## **Statement of Compliance Access for People with a Disability**

### **Proposed Mixed Use Development**

**52-62 May Rd Narrabeena**

**Report Type:** Statement of Compliance - BCA Access Provisions  
**Development:** 52-62 May Rd Narrabeena

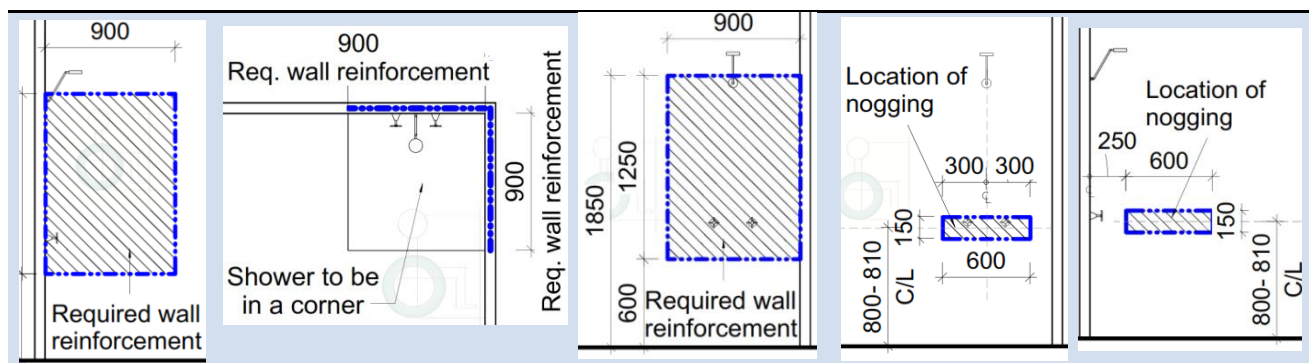
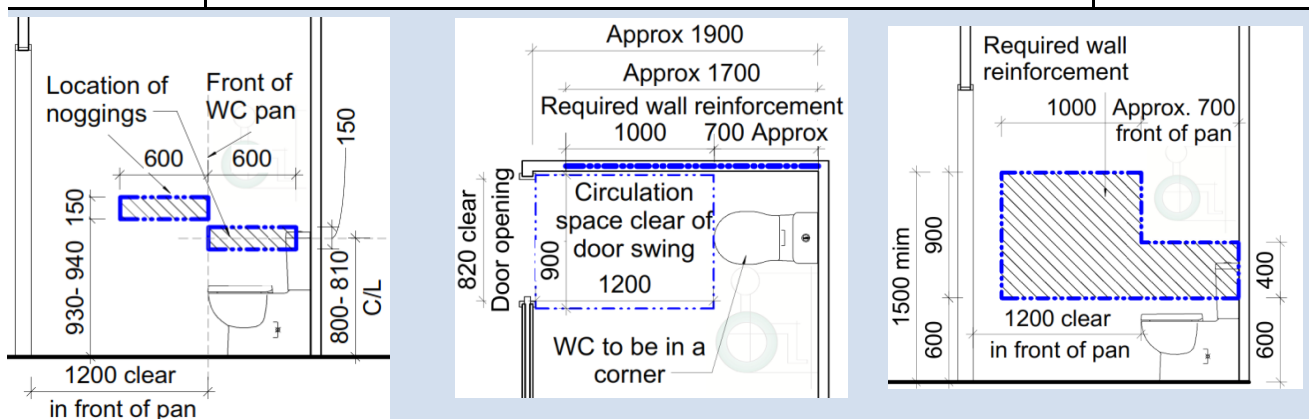
Since **2** of the units (**12 & 13**) already comply with the Adaptable unit requirements, these units are also capable of satisfying the intent of Silver level of Livable Housing Guidelines as noted in the table below.
